SAFETY ALERT

Subject: TPP NW1 volume Page 797, Airport Diagram at Sidney, MT, Sidney-Richland Muni (SDY), missing taxiways and apron area

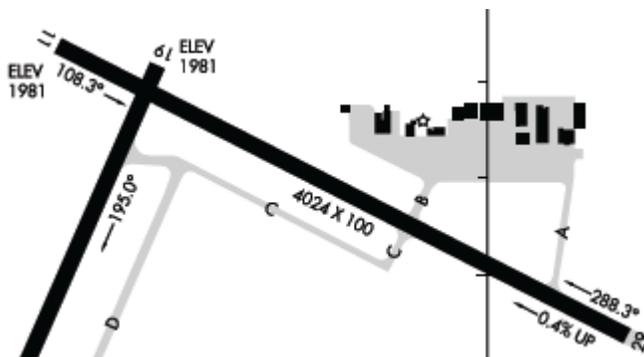
Airport Diagram at Sidney, MT, Sidney-Richland Muni (SDY), Terminal Procedures Publication, volume NW1, effective 12/10/15, page 797, is missing taxiways and apron area. Below is a snapshot of the corrected portion of the chart:

You may download the correct airport diagram file at (SDY) for the NW1 volume, page 797, at <http://aeronav.faa.gov/d-tp/1513/05303AD.PDF>. A replacement DDTPPC_201513.zip file, including the replacement file, has been uploaded to all FTP folders.
